Public Works Committee Agenda
April 16, 2025
Reedsburg City Hall Council Chambers
5:30 PM

Date: 9/11/2024
 To: Sarah Heltemes
 C.D. Smith Construction, Inc.
 125 Camelot Drive
 Fond du Lac, WI 54935
 From: Billie Kershaw, Project Engineer
 Project: City of Reedsburg -- 2024 Wastewater Improvements Contract A - WWTP
 Subject: **Conduit Materials**

Date: 11/25/2024
 To: Sarah Heltemes
 C.D. Smith Construction, Inc.
 125 Camelot Drive
 Fond du Lac, WI 54935
 From: Billie Kershaw, Project Engineer
 Project: City of Reedsburg -- 2024 Wastewater Improvements Contract A - WWTP
 Subject: **Structure 90 Floor Changes**
 Attachments: Plan Markup and Quote - RFP #7

Date: 2/12/2025
 To: Sarah Heltemes
 C.D. Smith Construction, Inc.
 125 Camelot Drive
 Fond du Lac, WI 54935
 From: Billie Kershaw, Project Engineer
 Project: City of Reedsburg -- 2024 Wastewater Improvements Contract A - WWTP
 Subject: **316 SS Piping Upgrade at LS**
 Attachments: Cost Change Documentation

1.0 Change

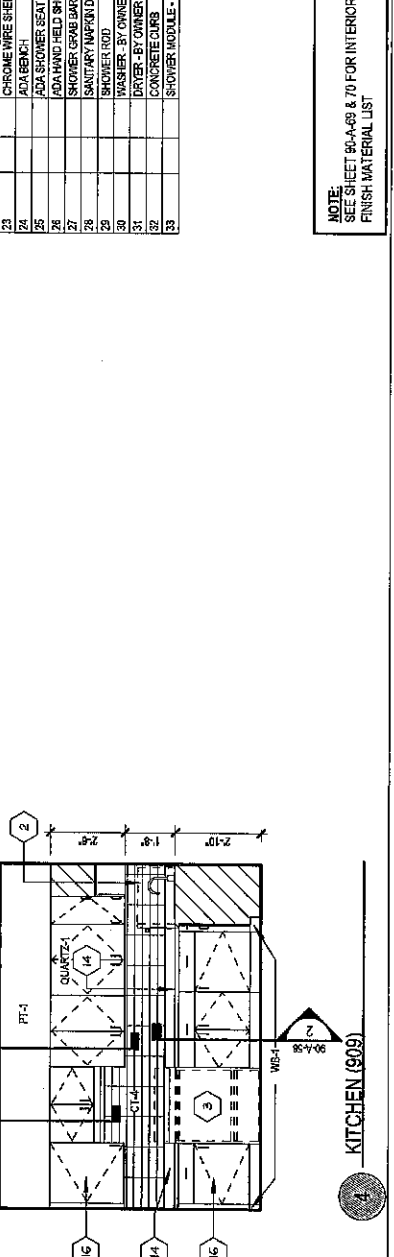
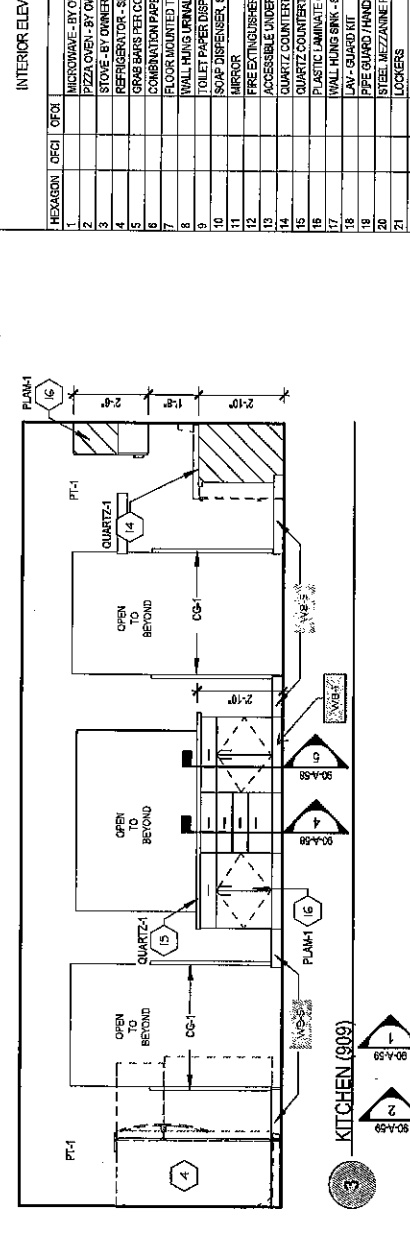
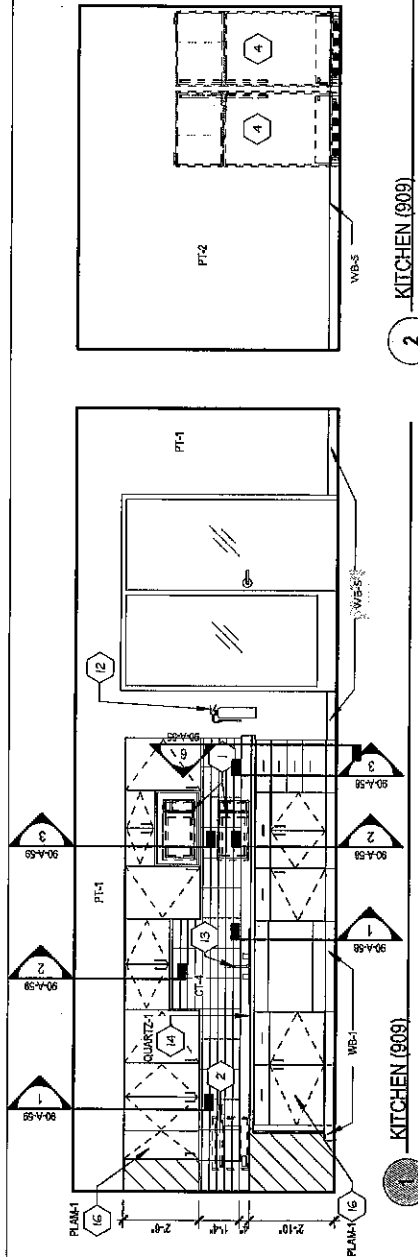
- MENS RR-912 - revise rubber wall base to WB-2
- WOMENS RR-911 - revise rubber wall base to WB-2
- UNISEP RR-916 - revise WB-1 to WB-5
- ADA SHOWER-917 - revise WB-1 to WB-5
- SHOWER-918 - revise WB-1 to WB-5
- SHOWER-919 - revise WB-1 to WB-5
- LOCKER ROOM-920 - revise WB-1 to WB-5

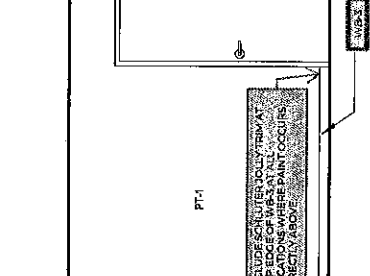
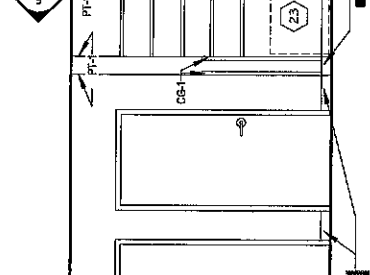
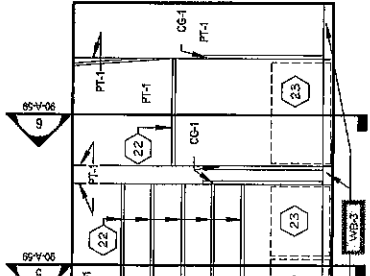
REVERSE WB-4 TO FLUID APPLIED FLOOR BUILT UP BASE TO 9" AT ALL WB-4 LOCATIONS

| INTERIOR FINISH MATERIAL LIST | | | | | | |
|-------------------------------|---|---------------------------------------|---------------------------|--------------|---|--|
| GROUT | | | | | | |

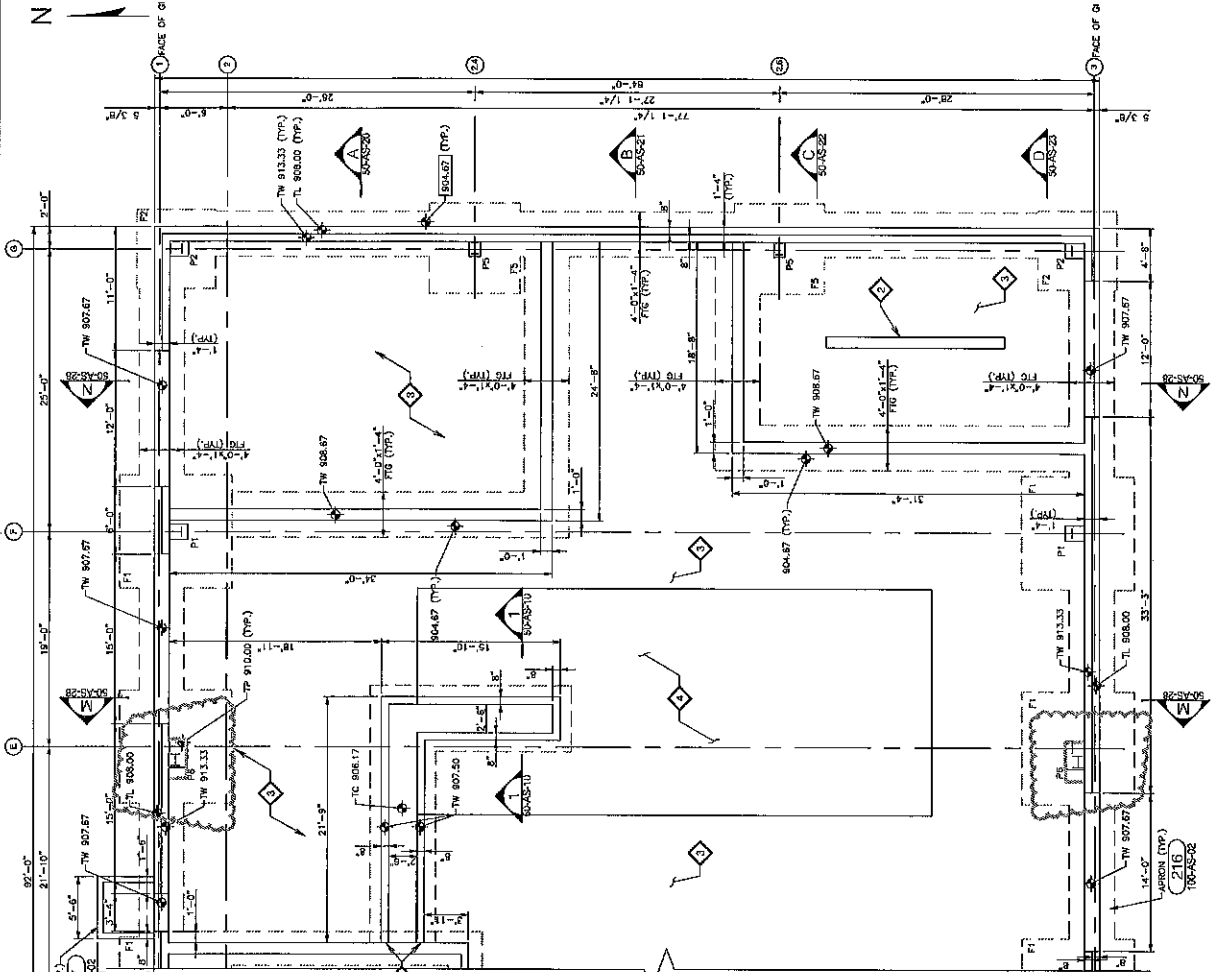
| INTERIOR FINISH MATERIAL LIST | | | | | | |
|-------------------------------|---|---------------------------------------|---------------------------|--------------|---|--|
| GROUT-2 | MAPEI | | 5029 IVORY | | | |

| INTERIOR FINISH MATERIAL LIST | | | | | | |
|-------------------------------|---------------------------------|-------------------|--------------------|---------------------------------------|-----------------------------|--|
| PT-1 | SHERWIN WILLIAMS | — | STONE LION SW 7507 | — | | |

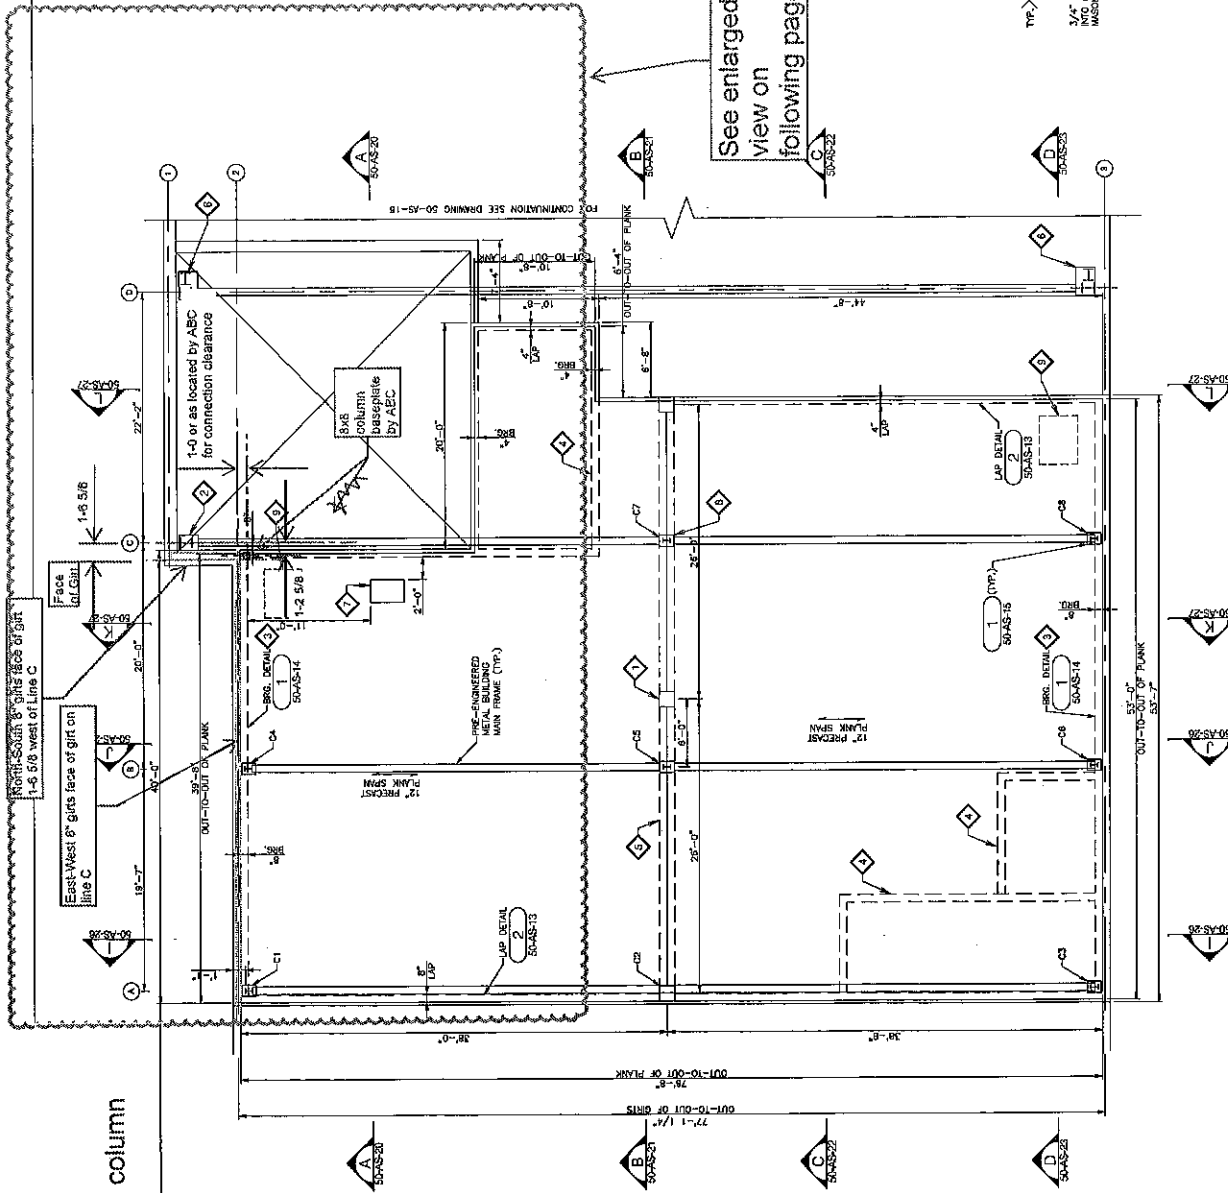
| INTERIOR FINISH MATERIAL LIST | | | | | | |
|-------------------------------|---------------------------------|-------------------|--------------------|---------------------------------------|-----------------------------|--|
| LABEL | MFR / SUPPLIER | STYLE | COLOR | SIZE | NOTES | |

At the present time, we cannot assess or evaluate the overall impact of the changed work on our original scope of work.

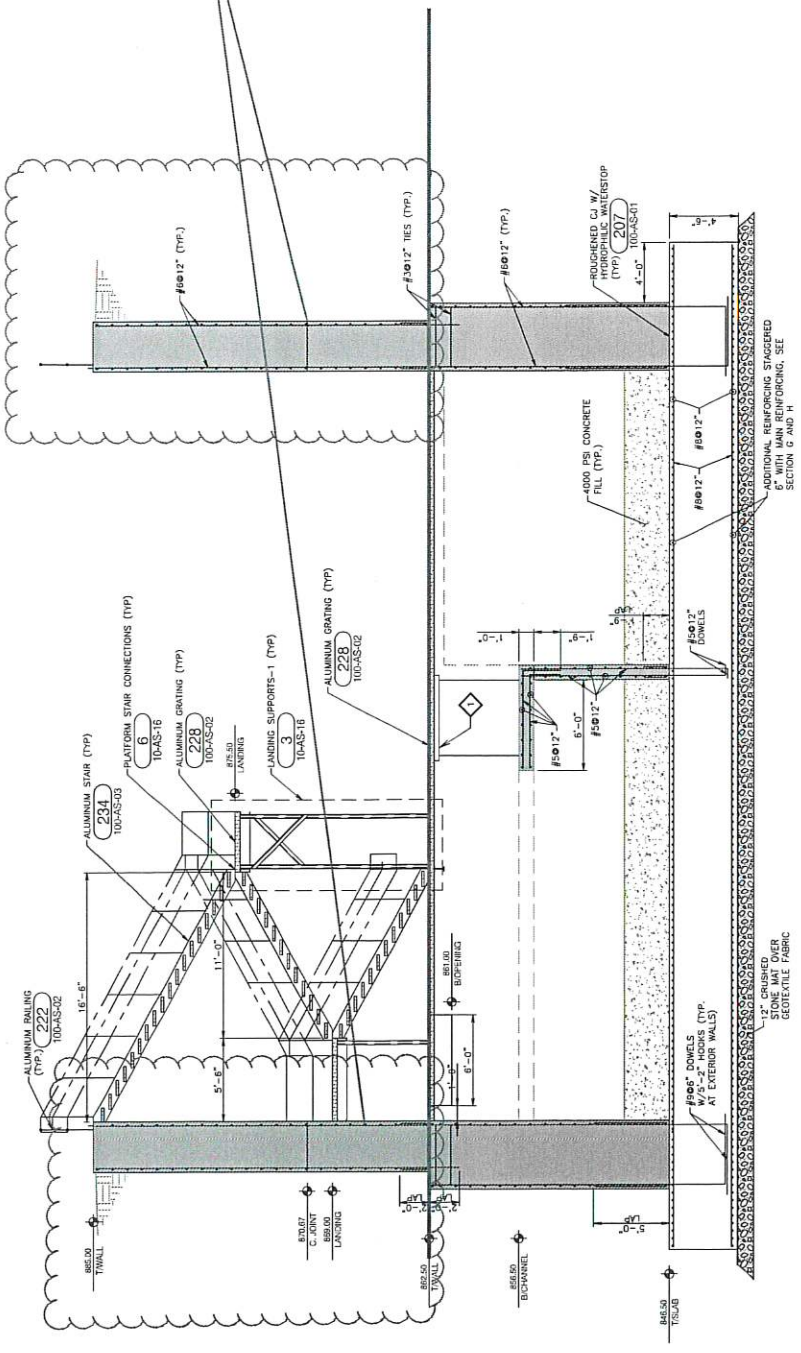
This proposal only covers the direct costs of labor, materials and equipment to execute the changed work described in the proposal.

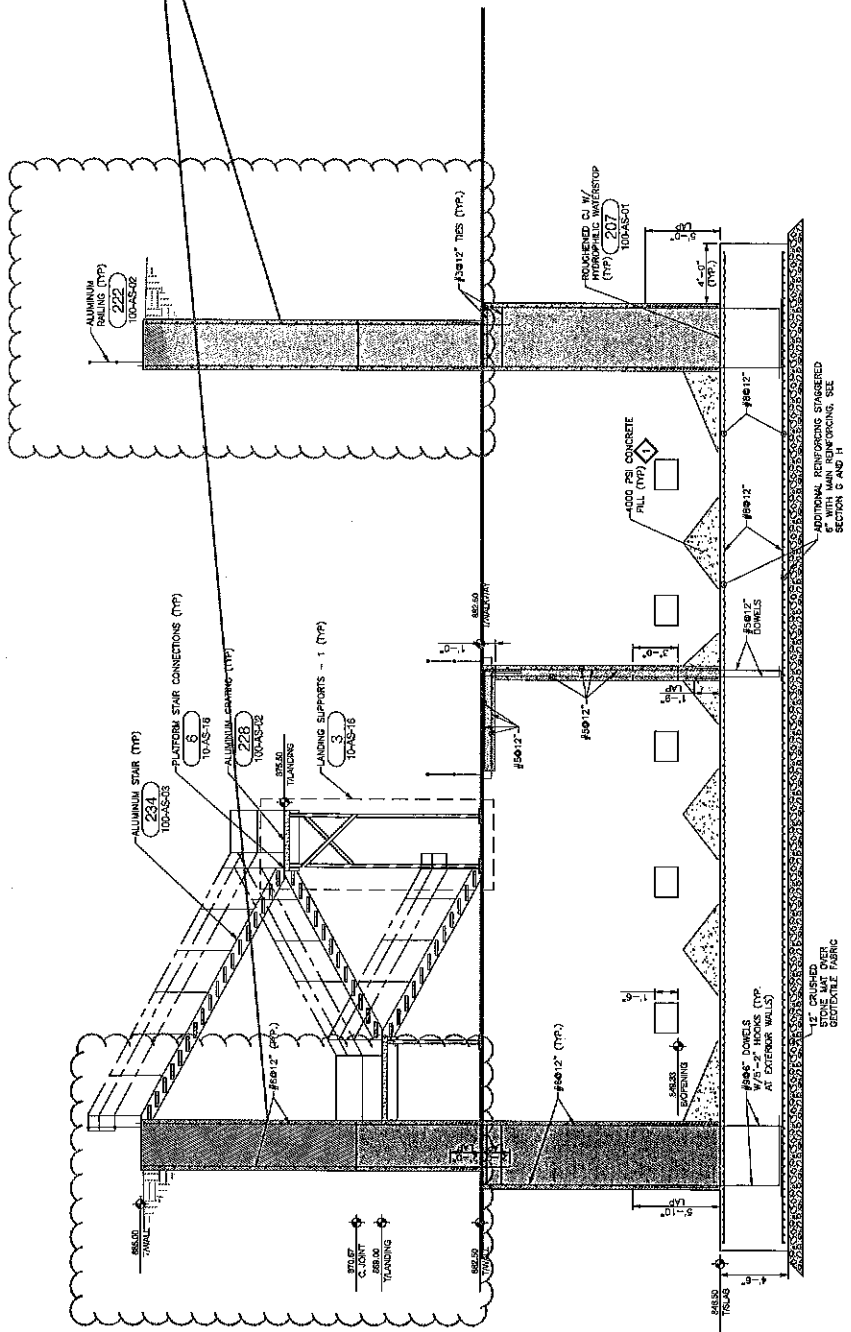
Date: 1-23-2025

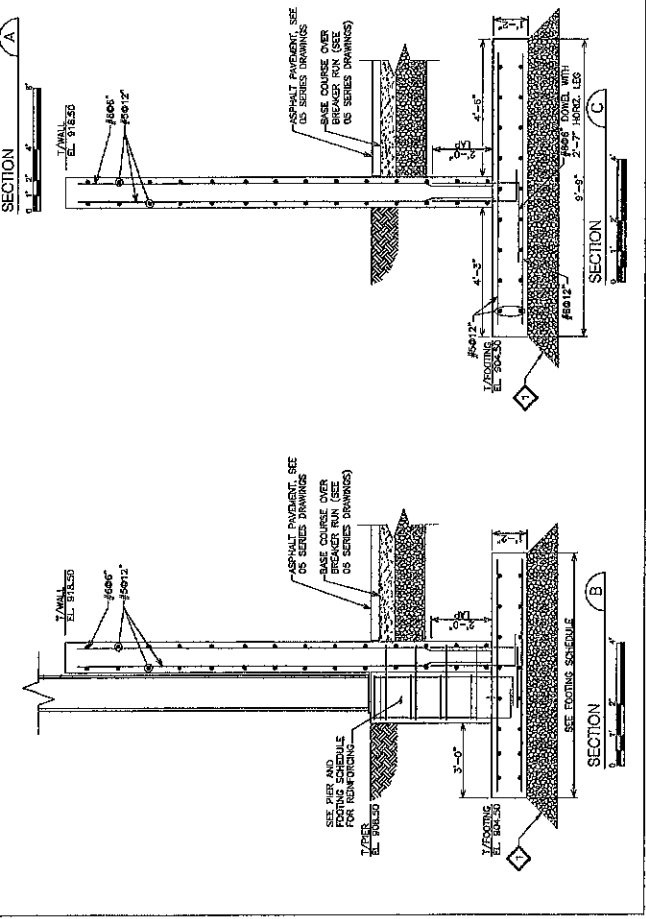
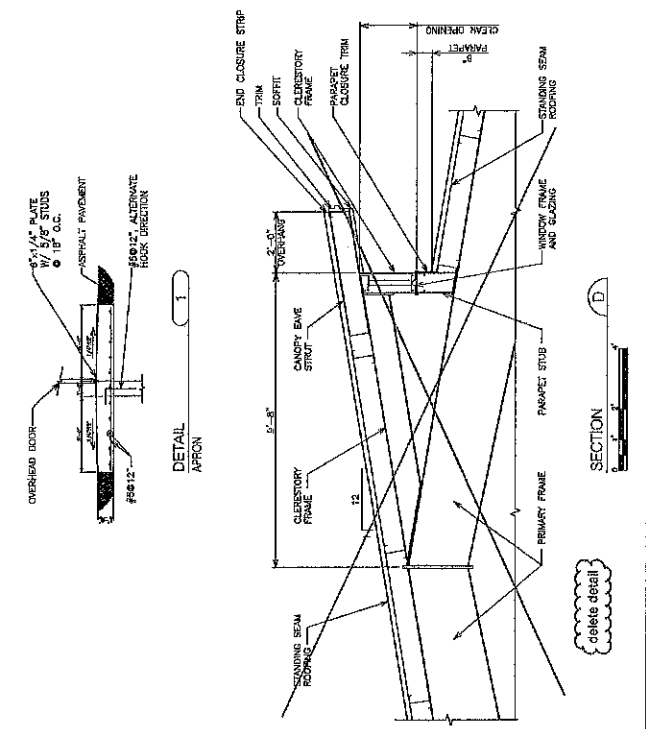
IPS Job #J002471
RFP-014
